Re: Academy Acres, Unit 13 (Tract A-2)

DRAINAGE REPORT

ACADEMY ACRES

UNIT - 13.

FIGURE II
TYPICAL LOT DRAINAGE

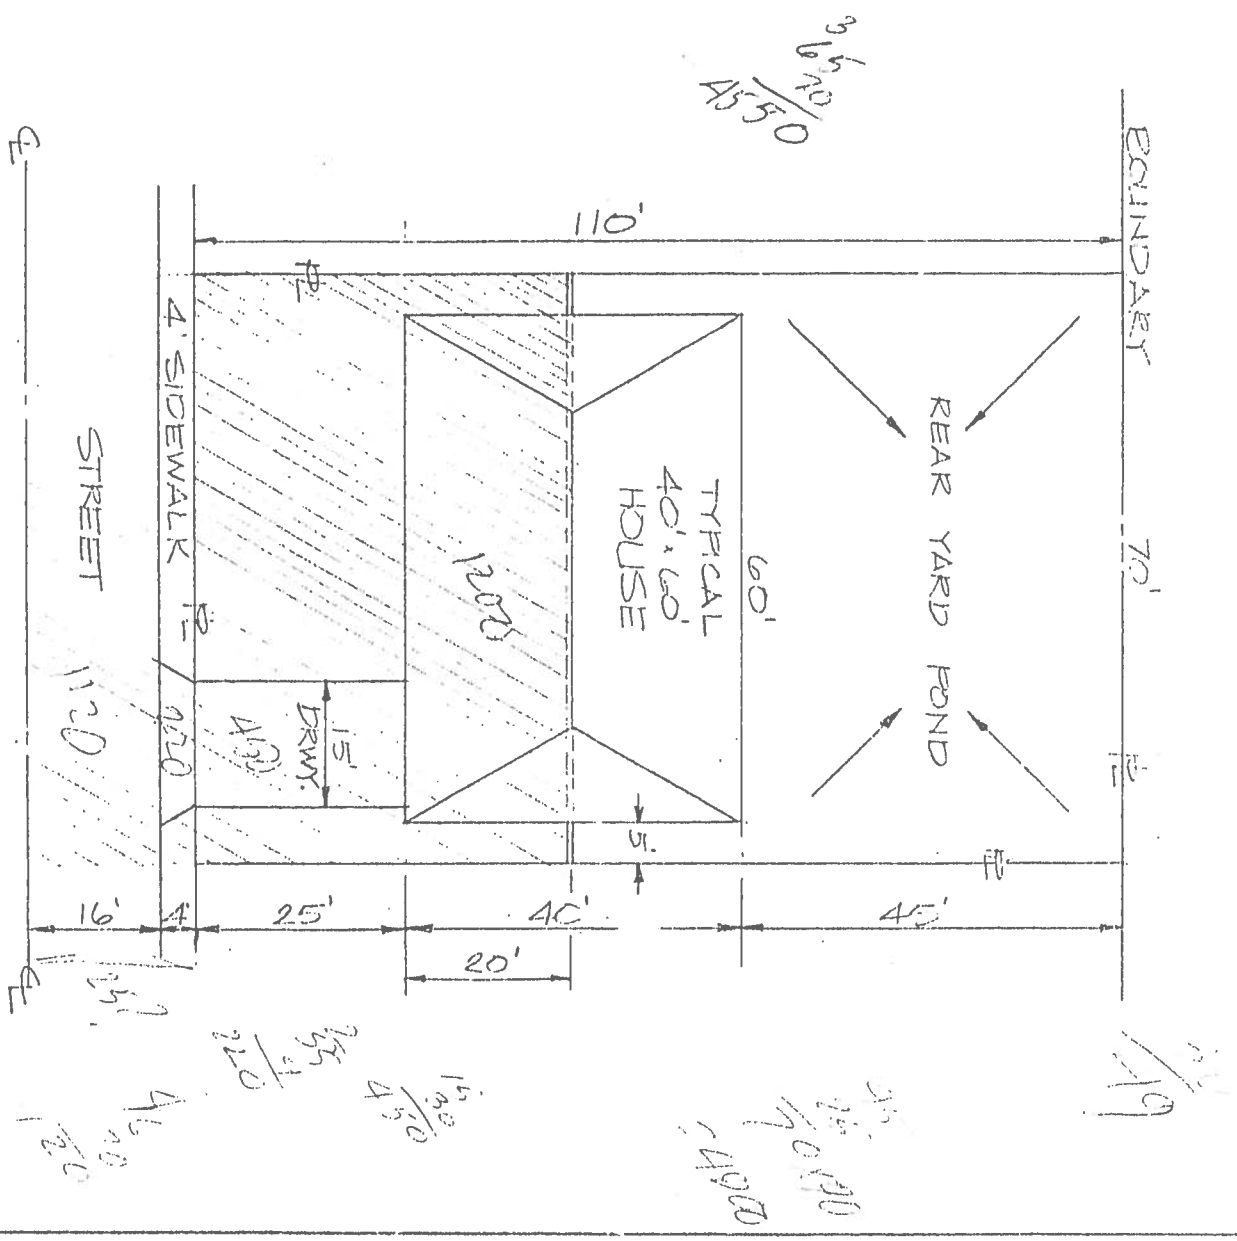
3. Since the theoretical flows in Wyoming Blvd. on the east are slightly above the top of curb, it is recommended that the first course of the fence along the rear property line of those lots backing to Wyoming Blvd. be filled with grout. *What if first course is less back of wall? 2*
